# UNITED STATES PATENT AND TRADEMARK OFFICE

APPLICATION NO.	FILING DATE	FIRST NAMED INVENTOR	ATTORNEY DOCKET NO.	CONFIRMATION NO.
10/749,073	12/30/2003	Asad Ali	04428 (3883.00033)	7941
35374	7590	01/27/2006	EXAMINER	
LEAR CORPORATION, BLISS MCGLYNN, P.C. 2075 WEST BIG BEAVER ROAD SUITE 600 TROY, MI 48084			NELSON JR, MILTON	
			ART UNIT	PAPER NUMBER
			3636

<b>Office Action Summary</b>	Application No.	Applicant(s)
	10/749,073	ALI ET AL.
	Examiner Milton Nelson, Jr.	Art Unit 3636

Title: VEHICLE SEAT ASSEMBLY HAVING A VEHICLE SENSING SYSTEM AND REINFORCING INSERTS POSITIONED THEREIN  
Inventor's Name: Ali et al. - Docket No. 04428 (3883.00033)

Figure 1

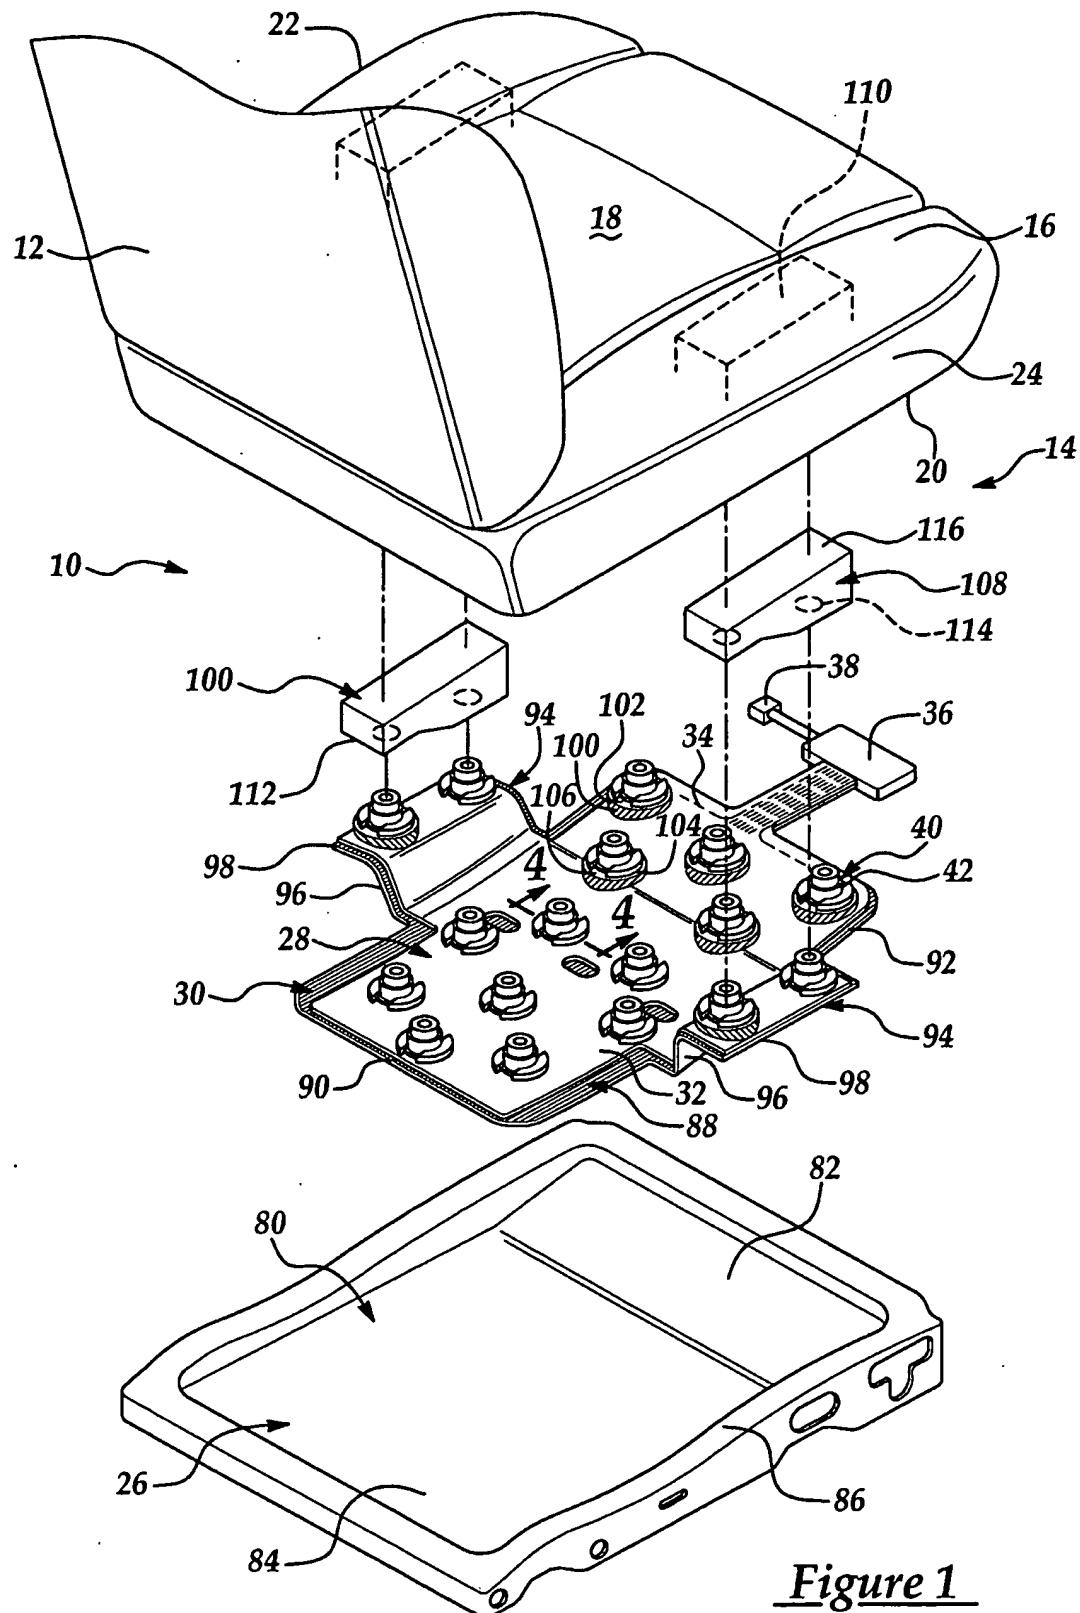
The drawing sheet containing Figure 1 has been objected to as failing to comply with 37 CFR 1.84(p)(4) because reference character “100” has been used to designate both the insert and the pedestal. Corrected drawing sheets in compliance with 37 CFR 1.121(d) are required in reply to the Office action to avoid abandonment of the application. Any amended replacement drawing sheet should include all of the figures appearing on the immediate prior version of the sheet, even if only one figure is being amended. Each drawing sheet submitted after the filing date of an application must be labeled in the top margin as either “Replacement Sheet” or “New Sheet” pursuant to 37 CFR 1.121(d). If the changes are not accepted by the examiner, the applicant will be notified and informed of any required corrective action in the next Office action. The objection to the drawings will not be held in abeyance.

disapproved  
1/21/06
